#### SERVICE LETTER

**SL87-215/OES**April 1987

Piston for engine type T23LH, T23LH-2, T23LS, T23LS-2, T23LH-4 and T23LS-4.

ENGINE TYPE 23L - PISTON WITH 4 RINGS. NEW DESIGN

ENGINE TYPE 23L - PISTON WITH 5 RINGS. INITIAL DESIGN

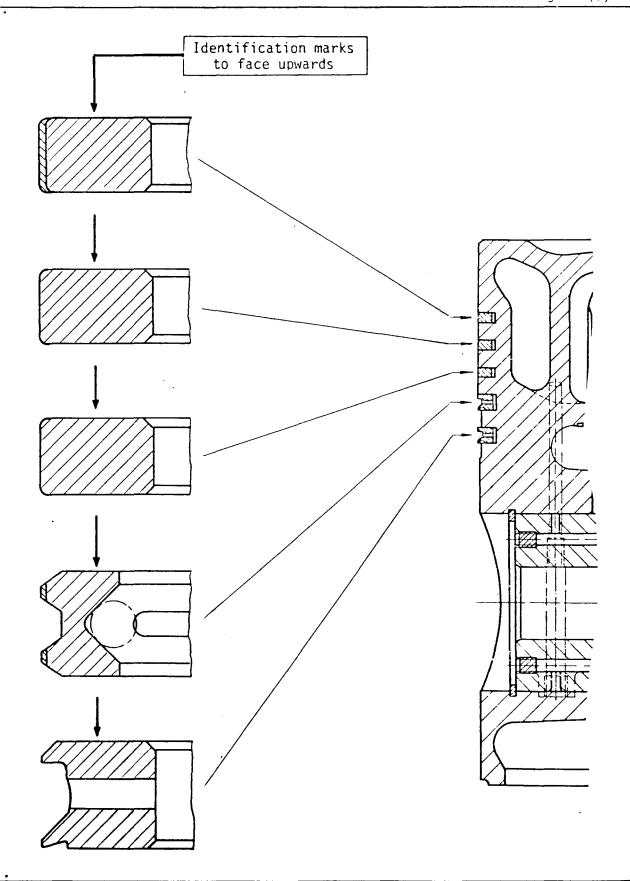
For engine of the above mentioned types a new piston design in nodular cast iron has been introduced. The new design is direct to identify by the piston ring package comprising 4 rings in contrast to the previous design, which comprised 5 rings. See enclosed TECHNICAL INFORMATION 307-S1.

The new 4-ring piston fully replaces the previous 5-ring piston.

It is acceptable to run an engine with any combination of previous and new piston design.

For the new piston design following ring package is used:

Ring No. 1 (top ring): Plain compression ring chrome-plated.

Ring No. 2 : Plain compression ring.

Ring No. 3 : Taper-faced ring with

inner step.

Ring No. 4 : Coil-spring loaded

oil control ring.

The rings No. 1, 2 and 4 are similar to those used in the previous 5-ring piston design.

Ring No. 3 (taper faced with inner step) is of a new design with function as compression ring and oil control ring as well. It can be separately ordered with plate/item reference 30701-17H/1909.

Please observe that in order to ensure correct function of the piston ring pack it is important to install the piston rings in correct order. Furthermore, each of the rings must be filled in correct direction concerning the profile and the running surface.

Correct direction is characterized by the identification mark, stamped into the rings close to the ring gap, is facing upwards.
